Title of Change:	FPF3188AUCX New Carrier Tape Design Qualification
Effective date:	19 Apr 2021
Contact information:	Contact your local ON Semiconductor Sales Office or Michelle.Lyn.Alaba@onsemi.com
Type of notification:	This Product Bulletin is for notification purposes only. ON Semiconductor will proceed with implementation of this change upon publication of this Product Bulletin.
Change Category:	Assembly Change
Change Sub-Category(s):	Material Change

Qualification of New Carrier Tape Design for FPF3188AUCX WLSCP Device

PCN#: PB23904X
Issue Date: Apr 18, 2021

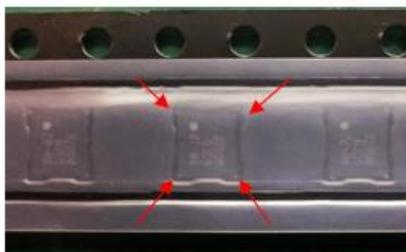
New carrier tape design with Corner relief for FPF3188AUCX WLSCP Device with changes comparison as below:

FROM: No Corner Relief

TO: With Corner Relief
